Access Audit Site Report

Goose Island State Park

Accessibility Evaluation

Inspection Date: 10/07/2021

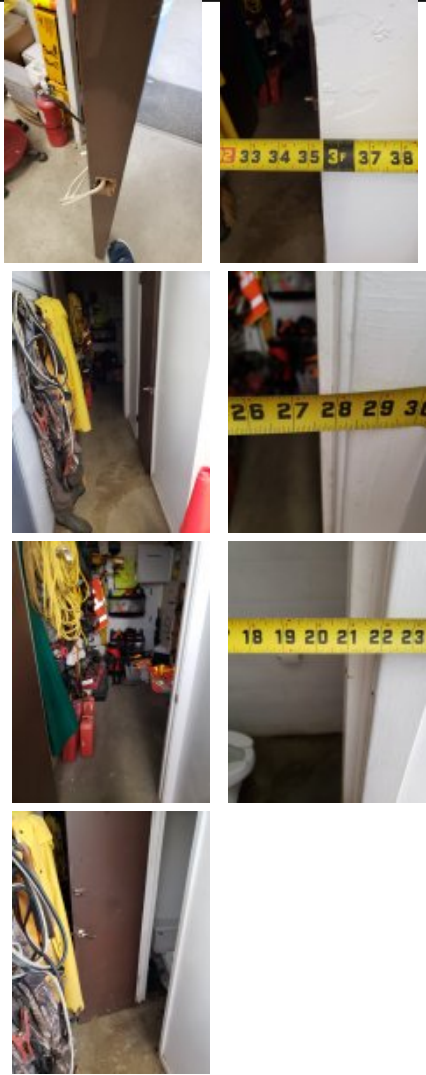
25	Headquarters Area: Headquarters Bathroom Right	[28.133565, -96.9843108]	The mirror is mounted too high. Mirrors not located above lavatories or countertops shall be installed with the bottom edge of the reflecting surface 35 inches maximum above the finish floor or ground.	Bottom edge of mirror not above sink is 40.25" aff	Lower mirror not over a sink or counter to max 35" aff to the reflective surface	2015 ABAAS Section: 603.3 2012 TAS Section: 603.3 2010 ADAS Section: 603.3

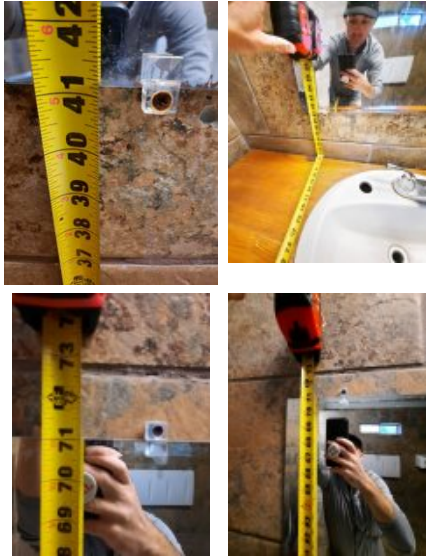
Finding Number	Area Description	Lat/Long	Finding	As Built	Recommendation	Citation	Photos	Figure
56	Warbler Way: Warbler Way Restroom Parking	[28.1368125 , -96.988505 8]	The access aisle is not a minimum 5 feet wide. A car accessible parking stall's access aisle must be a minimum of 5 feet wide measured from centerline to centerline. Where the access aisle is not adjacent to another parking space or access aisle, measurements shall be permitted to include the full width of the line defining the access aisle.	Possible/intended access aisle is 57" wide	Repaint access aisles to be 5' each	2015 ABAAS Section: 502.3.1 2012 TAS Section: 502.3.1 2010 ADAS Section: 502.3.1	 	
57	Warbler Way: Warbler Way Restroom Parking	[28.136803, -96.988505 8]	There are no van accessible parking stalls. 1 in every 6, minimum of one, required accessible stalls must be a van accessible stall. There are a total of 6 parking stalls in the parking lot that could be reasonably associated with this facility. There should be a minimum of 1 accessible stalls with a minimum of 1 being designed as van accessible.	lacks van stall	Add van parking sign to 1 accessible stall and repaint stall and access aisle to 11' and 5' or 8' and 8' per the table	2015 ABAAS Section: F208.2, F208.2.4 2012 TAS Section: 208.2, 208.2.4 2010 ADAS Section: 208.2, 208.2.4

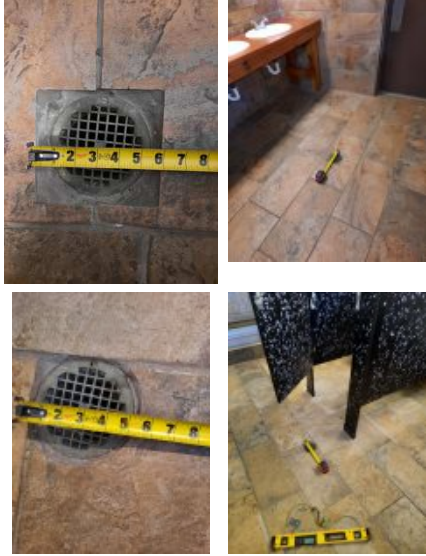
Finding Number	Area Description	Lat/Long	Finding	As Built	Recommendation	Citation	Photos	Figure
60	Warbler Way: Warbler Way Restroom Parking	[28.1367605 , -96.988492 4]	The parking sign is mounted too low. Parking space identification signs shall include the International Symbol of Accessibility complying with. Signs identifying van parking spaces shall contain the designation "van accessible." Signs shall be 60 inches minimum above the finish floor or ground surface measured to the bottom of the sign.	The parking sign is mounted too low (42.75" above ground level).	Raise existing accessible parking signs so lowest end of bottom sign is min 60" aff	2015 ABAAS Section: 502.6 2012 TAS Section: 502.6 2010 ADAS Section: 502.6

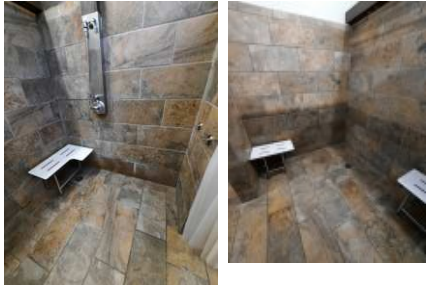
Finding Number	Area Description	Lat/Long	Finding	As Built	Recommendation	Citation	Photos	Figure
61	Warbler Way: Warbler Way Restroom Parking	[28.13295, -96.98463]	The accessible route is constructed such that a park vehicle can obstruct the minimum 36 inch width. Parking spaces and access aisles shall be designed so that cars and vans, when parked, cannot obstruct the required clear width of adjacent accessible routes.	Placement of yellow parking bumper to the right of the identified accessible stall may obstruct the possible/intended access aisle	Relocate parking and stripe a no parking zone or access aisle at entry to AR to prevent cars from blocking AR	2015 ABAAS Section: 502.7 2012 TAS Section: 502.7 2010 ADAS Section: 502.7		
62	Warbler Way: Warbler Way Men's Restroom	[28.1367179 , -96.988588 9]	The restroom sign does not comply with one or more applicable requirements for the location, height, and properties of the sign.	Lacks compliant signage - lacks Braille, raised characters, symbol of accessibility	Replace sign with one of contrasting colors that includes Braille, raised characters, and the symbol of accessibility and mount on the wall, latch side of the door, 48" to the baseline of the lowest character and 60" to the baseline of the highest character.	2015 ABAAS Section: F216.2, 703.1, 703.2, 703.5, 703.6 2012 TAS Section: 216.2, 703.1, 703.2, 703.5, 703.6 2010 ADAS Section: 216.2, 703.1, 703.2, 703.5, 703.6

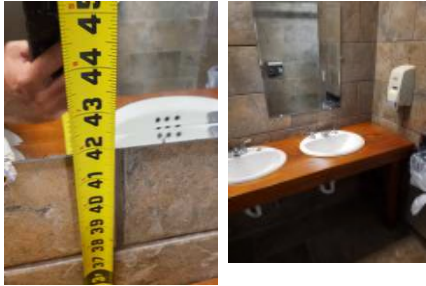
65	Warbler Way: Warbler Way Men's Restroom	[28.1367072 , -96.988588 9]	The rim of the urinal is too high. Wall-hung urinals must be provided with an elongated rim projecting a minimum of 13 1/2 inches from the wall and a maximum of 17 inches above the floor.	Rim of the urinal at 19.75" above the finished floor	Lower urinal so that rim height is max 17" aff	2015 ABAAS Section: 605.2 2012 TAS Section: 605.2 2010 ADAS Section: 605.2

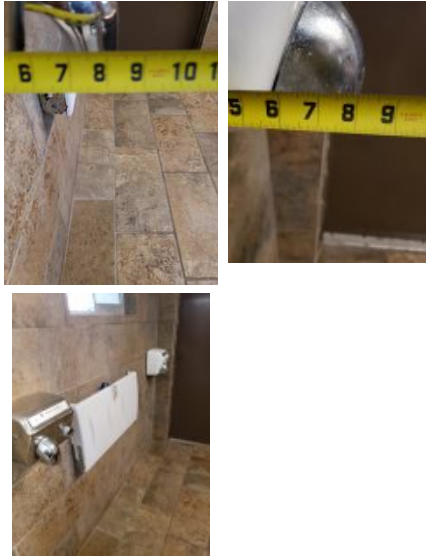
75	Warbler Way: Warbler Way Men's Restroom	[28.1367132 , -96.988580 9]	Exterior doors exceed 8.5 lbs of force to open; fire doors shall have a minimum opening force allowable by the appropriate administrative authority	men's- 15 lbf	Inspect, adjust, and maintain 8.5 lbf to open exterior doors as a smart practice	2010 ADAS Section: 404.2.9		
76	Warbler Way: Warbler Way Women's Restroom	[28.1367013 , -96.988583 6]	The restroom sign does not comply with one or more applicable requirements for the location, height, and properties of the sign.	Restroom signage lacks Braille, raised characters, symbol of accessibility	Replace sign with one of contrasting colors that includes Braille, raised characters, and the symbol of accessibility and mount on the wall, latch side of the door, 48" to the baseline of the lowest character and 60" to the baseline of the highest character.	2015 ABAAS Section: F216.2, 703.1, 703.2, 703.5, 703.6 2012 TAS Section: 216.2, 703.1, 703.2, 703.5, 703.6 2010 ADAS Section: 216.2, 703.1, 703.2, 703.5, 703.6

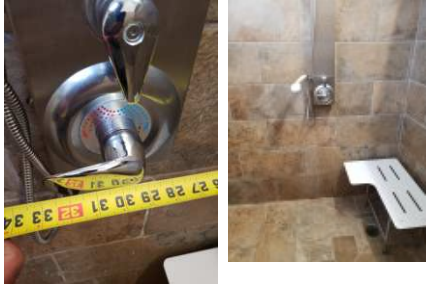
81	Warbler Way: Warbler Way Women's Restroom	[28.136712, -96.988586 3]	There are not enough accessible toilet compartments. A minimum of 1 must be wheelchair accessible .	Lacks a wheelchair accessible toilet compartment	Create a wheelchair accessible stall with grab bars and fixtures mounted in correct locations and at correct heights	2015 ABAAS Section: F213.3.1 2012 TAS Section: 213.3.1 2010 ADAS Section: 213.3.1

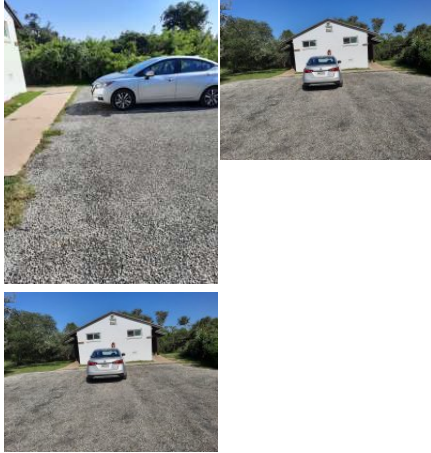
Finding Number	Area Description	Lat/Long	Finding	As Built	Recommendation	Citation	Photos	Figure
88	Warbler Way: Warbler Way Women's Restroom	[28.1367155 , -96.988586 3]	The hand dryers project more than 4 inches into the circulation path. Wall-mounted objects that have leading edges between 27 inches and 80 inches from the floor must not project more than 4 inches into the circulation path. Protruding objects that extend to the floor or within 27 inches of the floor are cane detectable and are therefore not hazardous. Where it is necessary or desirable to have objects protrude from the wall, a manner of cane detection must be provided.	Hand dryers protrude 8" and 8.5"	Relocate protruding objects or place cane detectable warning or bollard at foot of item	2015 ABAAS Section: 307.2 2012 TAS Section: 307.2 2010 ADAS Section: 307.2		
89	Warbler Way: Warbler Way Women's Restroom	[28.1367061 , -96.988599 7]	There is a change in level greater than 1/4 inch. 1/4 inch is the maximum vertical rise. Changes in level between 1/4 inch and 1/2 inch must be beveled at 1:2 or less. Changes in level greater than 1/2 inch must be by way of a ramp.	CIL of .25" at floor drain	Repair, bevel or ramp CIL along accessible route (AR) to max .25".	2015 ABAAS Section: 303.3 2012 TAS Section: 303.3 2010 ADAS Section: 303.3

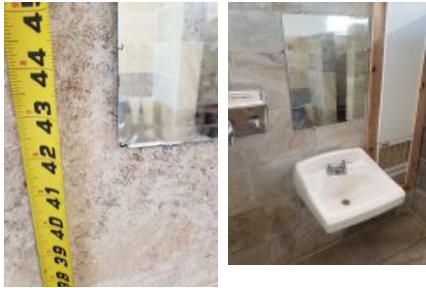
91	Warbler Way: Warbler Way Women's Restroom	[28.1367132 , -96.988588 9]	The alternate shower is missing grab bars. In alternate roll-in type shower compartments, grab bars shall be provided on the back wall and the side wall farthest from the compartment entry. Grab bars shall not be provided above the seat. Grab bars shall be installed 6 inches maximum from adjacent walls.	Lacks grab bars	Install grab bars in shower on the back wall and the side wall farthest from the compartment entry.	2015 ABAAS Section: 608.3.3 2010 ADAS Section: 608.3.3

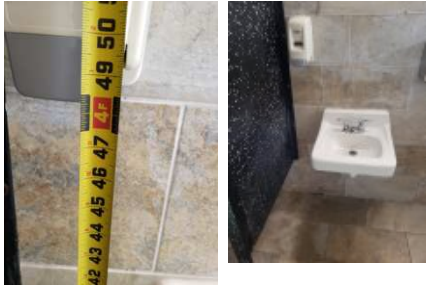
Finding Number	Area Description	Lat/Long	Finding	As Built	Recommendation	Citation	Photos	Figure
94	Bayberry: Bayberry EAR	[28.1352337 , -96.986537 1]	The running slope of walking surfaces shall not be steeper than 1:20. The cross slope of walking surfaces shall not be steeper than 1:48.	Running slopes of 7% and 9%, cross slopes of 4.5% and 3%	Correct running slopes to max 5% and cross to max 2.08%.	2012 TAS Section: 403.3 2010 ADAS Section: 403.3

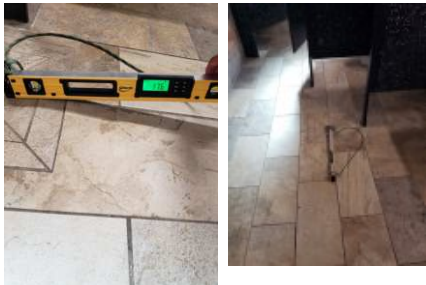
Finding Number	Area Description	Lat/Long	Finding	As Built	Recommendation	Citation	Photos	Figure
99	Bayberry: Bayberry Men's Restroom	[28.1352585 , -96.986571 9]	The restroom sign does not comply with one or more applicable requirements for the location, height, and properties of the sign.	Lacks Braille lettering on restroom signage	Acquire and mount signage, including Braille and access symbol mounted on wall, latch side of door, 48" to baseline of lowest character and 60" to baseline of highest character	2015 ABAAS Section: F216.2, 703.1, 703.2, 703.5, 703.6 2012 TAS Section: 216.2, 703.1, 703.2, 703.5, 703.6 2010 ADAS Section: 216.2, 703.1, 703.2, 703.5, 703.6		
100	Bayberry: Bayberry Men's Restroom	[28.1352704 , -96.986565 2]	The mirror is mounted too high. Mirrors must have the bottom edge of the reflecting surface a maximum of 40 inches above the floor if above a sink or counter. Mirrors not located above lavatories or countertops shall be installed with the bottom edge of the reflecting surface 35 inches maximum above the finish floor or ground.	Bottom edge of reflecting surface of mirror is 42" aff	Lower mirror so reflective surface is max 40" aff	2015 ABAAS Section: 603.3 2012 TAS Section: 603.3 2010 ADAS Section: 603.3

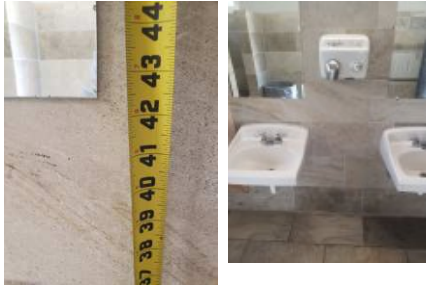
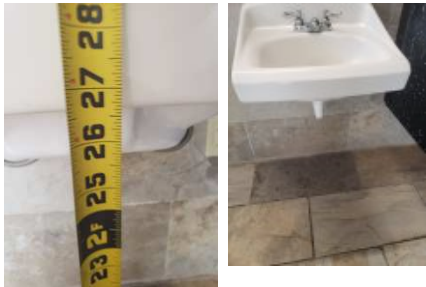
105	Bayberry: Bayberry Men's Restroom	[28.1352573 , -96.986569 2]	There are not enough accessible toilet compartments. The room contains 0 toilet compartments. A minimum of 1 must be wheelchair accessible .	Lacks toilet stall with required dimensions to be wheelchair accessible	Create a wheelchair accessible stall with grab bars and fixtures mounted in correct locations and at correct heights	2015 ABAAS Section: F213.3.1 2012 TAS Section: 213.3.1 2010 ADAS Section: 213.3.1

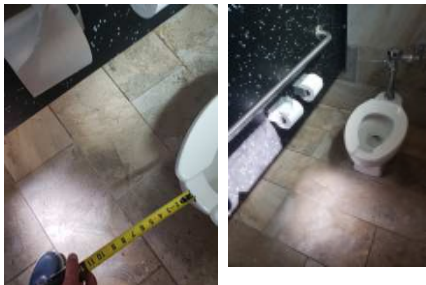
Finding Number	Area Description	Lat/Long	Finding	As Built	Recommendation	Citation	Photos	Figure
114	Bayberry: Bayberry Men's Restroom	[28.1352644 , -96.986566 6]	There are no accessible bathing or shower facilities. Where facilities for bathing are provided for the public, clients or employees, including showers or bathtubs, at least one shower or bathtub and support facilities such as lockers, and not less than 1 percent of all facilities, shall be accessible.	Lacks accessible bathing or shower facilities	Create an accessible shower in locker/bathing room.	2015 ABAAS Section: F213.3.6 2012 TAS Section: 213.3.6 2010 ADAS Section: 213.3.6		
115	Bayberry: Bayberry Men's Restroom	[28.1352763 , -96.986558 5]	Minimum maneuvering clearances at doors and gates shall comply with 404.2.4. Maneuvering clearances shall extend the full width of the doorway and the required latch side or hinge side clearance. The sweep period for doors with closers shall be adjusted so that from an open position of 70 degrees, the door will take at least 3 seconds to move to a point 3 inches from the latch, measured to the leading edge of the door.	men's- wall 44" back in pull side clearance, changing table in push side clearance, fast close	For all doors along the public circulation route, provide required maneuvering clearance on push and pull side of doors For all doors along the public circulation route, inspect, adjust, and maintain closing speed on door closers	2010 ADAS Section: 404.2.3, 404.2.7, 404.2.4, 404.2.11, 404.2.11 Exception

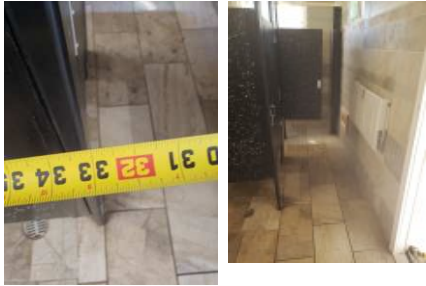
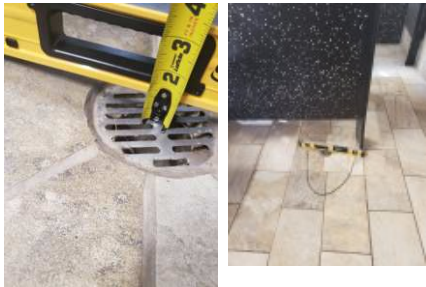
Finding Number	Area Description	Lat/Long	Finding	As Built	Recommendation	Citation	Photos	Figure
118	Bayberry: Bayberry Women's Restroom	[28.1352633 , -96.986566 6]	The mirror is mounted too high. Mirrors must have the bottom edge of the reflecting surface a maximum of 40 inches above the floor if above a sink or counter. Mirrors not located above lavatories or countertops shall be installed with the bottom edge of the reflecting surface 35 inches maximum above the finish floor or ground.	Bottom edge of reflecting surface of mirror is 42.5" aff	Lower mirror so reflective surface is max 40" aff	2015 ABAAS Section: 603.3 2012 TAS Section: 603.3 2010 ADAS Section: 603.3		
119	Bayberry: Bayberry Women's Restroom	[28.1352633 , -96.986566 6]	Knee clearance at 27 inches off the floor is not 8 inches minimum deep. The knee clearance, measured from the bottom of the apron or the outside bottom edge of the lavatory, must be 27 inches at a point located 8 inches back from the front edge and continuing to 11 inches minimum in depth at 9 inches above the floor. The top of the lavatory rim may be no higher than 34 inches.	Sink lacks knee clearance	Raise sink bowl to provide 27" knee clearance, in the alternative, acquire a shallower model	2015 ABAAS Section: 306.3.1, 306.3.2, 306.3.3, 306.3.4 , 306.3.5 2012 TAS Section: 306.3.2, 306.3.3, 306.3.4, 306.3.5, 306.3.1 2010 ADAS Section: 306.3.3, 306.3.2, 306.3.4, 306.3.5, 306.3.1

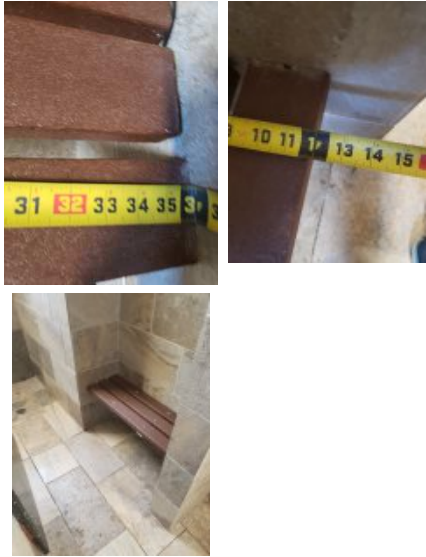
Finding Number	Area Description	Lat/Long	Finding	As Built	Recommendation	Citation	Photos	Figure
120	Bayberry: Bayberry Women's Restroom	[28.1352597 , -96.986574 6]	The water and drain pipes under the lavatory are not adequately insulated. Water supply and drain pipes under lavatories and sinks shall be insulated or otherwise configured to protect against contact. There shall be no sharp or abrasive surfaces under lavatories and sinks.	Sink lacks insulated pipes	Insulate exposed pipes under one sink	2015 ABAAS Section: 606.5 2012 TAS Section: 606.5 2010 ADAS Section: 606.5		
121	Bayberry: Bayberry Women's Restroom	[28.1352597 , -96.986570 6]	The baby changing table is not compliant. Baby changing tables are work surfaces. If fixed or built-in baby changing tables are provided, at least 5%, but not less than one, must comply with TAS 902 based TAS 226.1. Baby changing tables cannot violate the protruding object requirements in either an open or closed position since either position is a potential hazard for persons with visual impairments. Baby changing tables are not prohibited from being located in wheelchair accessible toilet compartments; however, the minimum space required for the compartment cannot be obstructed by the baby changing table in either an open or closed position. The clear floor space required for a baby changing table may overlap the water closet clearance since baby changing tables are considered convenience "fixtures" based on Advisory 604.8.1.1. The overlap is applicable only to the clear floor space and not to actual table itself. Baby changing tables must be dispersed throughout a space, however, an additional baby changing table is not required in a common use area of a toilet or bathing room when the only baby changing table is located in a toilet compartment.	Baby changing table protrudes 17.5" when in the open position	Relocate baby changing table to eliminate protrusion when in the open position.	2012 TAS Section: 226.1, 902.3, 604.3.2, 204.1, 226.1 Advisory, 226.2, 307.1, 604.8.1.1 Advisory, 902.1, 902.1 Advisory, 902.2

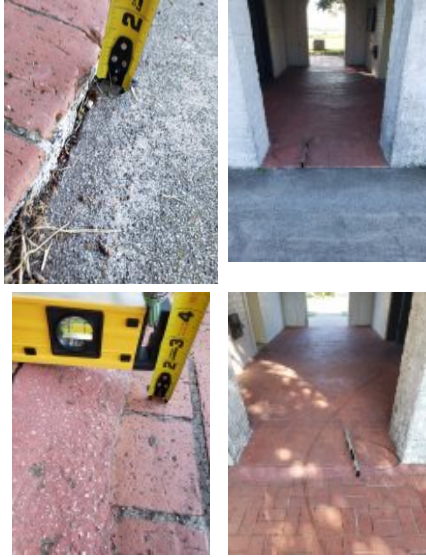
146	Day Use Area: Day Use Amenities	[28.1301754 , -96.984833 8]	Where provided, cooking surfaces shall be 15 inches (380 mm) minimum and 34 inches (865 mm) maximum above the ground.	grills 36" to cooking surface	Raise or lower cooking surface to be 15" min to 34" max above the ground; in the alternative, replace with a compliant surface as a smart practice.	2015 ABAAS Section: 1011.5.2

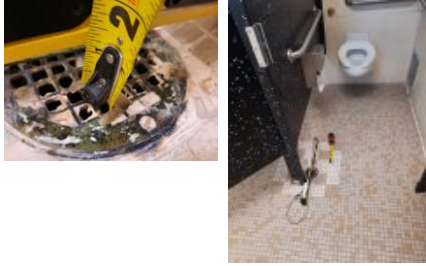
162	Day Use Area: Day Use Recreational Hall Women's Restroom	[28.1303268 , -96.985423 9]	The water and drain pipes under the lavatory are not adequately insulated. Water supply and drain pipes under lavatories and sinks shall be insulated or otherwise configured to protect against contact. There shall be no sharp or abrasive surfaces under lavatories and sinks.	pipes lack insulation	Insulate exposed pipes under one sink	2015 ABAAS Section: 606.5 2012 TAS Section: 606.5 2010 ADAS Section: 606.5

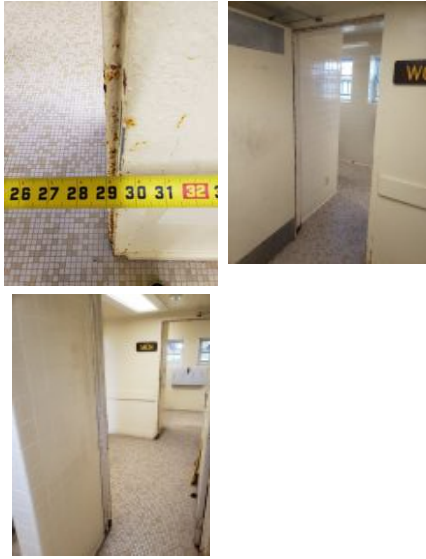
Finding Number	Area Description	Lat/Long	Finding	As Built	Recommendation	Citation	Photos	Figure
163	Day Use Area: Day Use Recreational Hall Women's Restroom	[28.1303197 , -96.985423 9]	Where a high forward reach is over an obstruction, the clear floor space shall extend beneath the element for a distance not less than the required reach depth over the obstruction. The high forward reach shall be 48 inches (1220 mm) maximum where the reach depth is 20 inches (510 mm) maximum. Where the reach depth exceeds 20 inches (510 mm), the high forward reach shall be 44 inches (1120 mm) maximum and the reach depth shall be 25 inches (635 mm) maximum. Where a clear floor or ground space allows a parallel approach to an element and the high side reach is over an obstruction, the height of the obstruction shall be 34 inches (865 mm) maximum and the depth of the obstruction shall be 24 inches (610 mm) maximum. The high side reach shall be 48 inches (1220 mm) maximum for a reach depth of 10 inches (255 mm) maximum. Where the reach depth exceeds 10 inches (255 mm), the high side reach shall be 46 inches (1170 mm) maximum for a reach depth of 24 inches (610 mm) maximum.	soap dispenser is 49" aff, coat hooks in stall at 64.25" aff	Lower operating mechanisms to max 48" above the finished floor (AFF) to highest operable part. Lower soap dispenser to max 46" above the finished floor (AFF) for a side reach over counter.	2015 ABAAS Section: 308.2.1, 308.3.2 2012 TAS Section: 308.2.1, 308.3.2 2010 ADAS Section: 308.2.1, 308.3.2

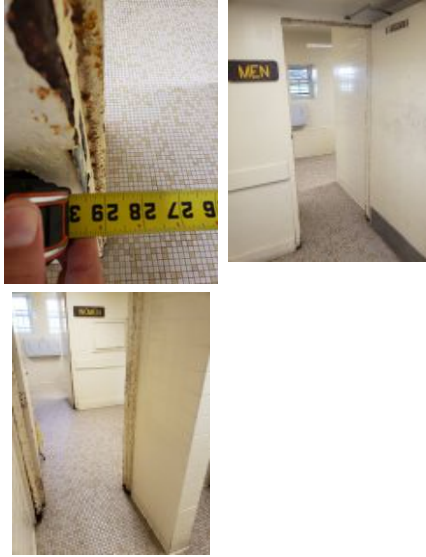
178	Day Use Area: Day Use Recreation Hall Men's Restroom	[28.1303008 , -96.985445 4]	The water and drain pipes under the lavatory are not adequately insulated. Water supply and drain pipes under lavatories and sinks shall be insulated or otherwise configured to protect against contact. There shall be no sharp or abrasive surfaces under lavatories and sinks.	Sink lacks insulated pipes	Insulate exposed pipes under one sink	2015 ABAAS Section: 606.5 2012 TAS Section: 606.5 2010 ADAS Section: 606.5

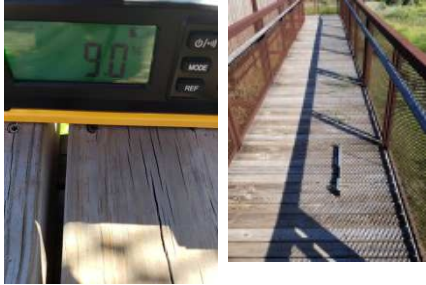
Finding Number	Area Description	Lat/Long	Finding	As Built	Recommendation	Citation	Photos	Figure
180	Day Use Area: Day Use Recreation Hall Men's Restroom	[28.1303339 , -96.985413 2]	The baby changing table is not compliant. Baby changing tables are work surfaces. If fixed or built-in baby changing tables are provided, at least 5%, but not less than one, must comply with TAS 902 based TAS 226.1. Baby changing tables cannot violate the protruding object requirements in either an open or closed position since either position is a potential hazard for persons with visual impairments. Baby changing tables are not prohibited from being located in wheelchair accessible toilet compartments; however, the minimum space required for the compartment cannot be obstructed by the baby changing table in either an open or closed position. The clear floor space required for a baby changing table may overlap the water closet clearance since baby changing tables are considered convenience "fixtures" based on Advisory 604.8.1.1. The overlap is applicable only to the clear floor space and not to actual table itself. Baby changing tables must be dispersed throughout a space, however, an additional baby changing table is not required in a common use area of a toilet or bathing room when the only baby changing table is located in a toilet compartment.	Baby changing table protrudes 17" when in the open position	Relocate baby changing table to eliminate protrusion when in the open position.	2012 TAS Section: 226.1, 902.3, 604.3.2, 204.1, 226.1 Advisory, 226.2, 307.1, 604.8.1.1 Advisory, 902.1, 902.1 Advisory, 902.2

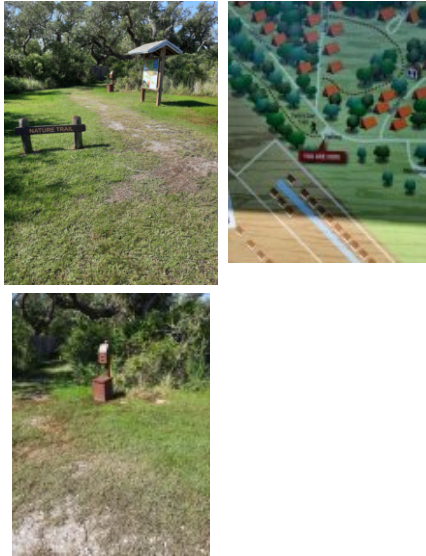
253	The Big Tree: The Big Tree	[28.1520204, -96.9768479]	The walkway contains abrupt vertical edges and/or variations over a 1/4 inch. 1/4 inch is the maximum vertical rise. Changes in level between 1/4 inch and 1/2 inch must be beveled at 1:2 or less. Changes in level greater than 1/2 inch must be by way of a ramp.	CIL of 1" along transition from parking to accessible route	Repair, bevel or ramp CIL along AR	2012 TAS Section: 303.2, 303.3 2010 ADAS Section: 303.2, 303.3

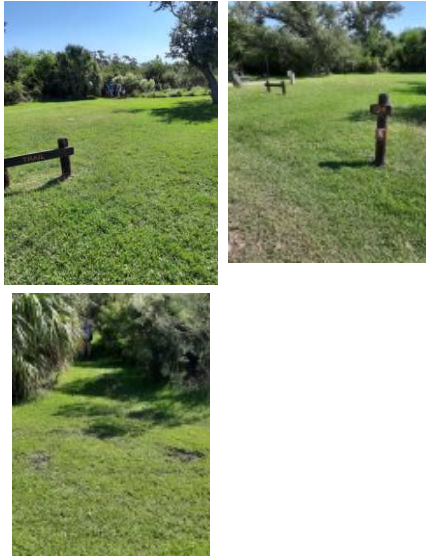
Finding Number	Area Description	Lat/Long	Finding	As Built	Recommendation	Citation	Photos	Figure
254	The Big Tree: The Big Tree	[28.1523649 , -96.976679 5]	There is a gap spaced greater than a 1/2 inch. Openings in floor or ground surfaces shall not allow passage of a sphere more than 1/2 inch diameter. Elongated openings shall be placed so that the long dimension is perpendicular to the dominant direction of travel.	Multiple gaps (5) greater than .5" along accessible route	Correct or fill gaps to be max .5"	2015 ABAAS Section: 302.3 2012 TAS Section: 302.3 2010 ADAS Section: 302.3

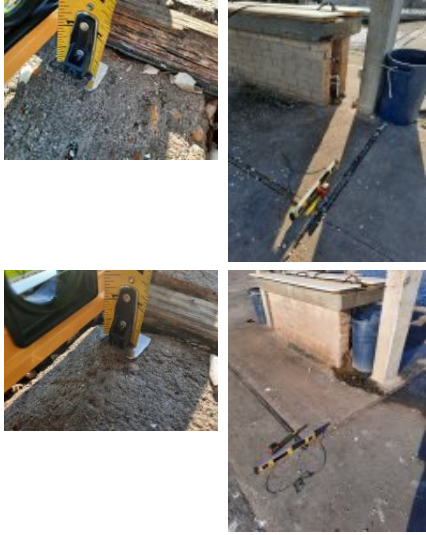
Finding Number	Area Description	Lat/Long	Finding	As Built	Recommendation	Citation	Photos	Figure
261	Trails And Trailheads: Warbler Way Campsites Unnamed Nature Trail	[28.13564, -96.98833]	The surface of trails, passing spaces, and resting intervals shall be firm and stable	Lacks firm and stable surface	Replace surface of trail with one that is firm and stable as a smart practice.	2015 ABAAS Section: 1017.2
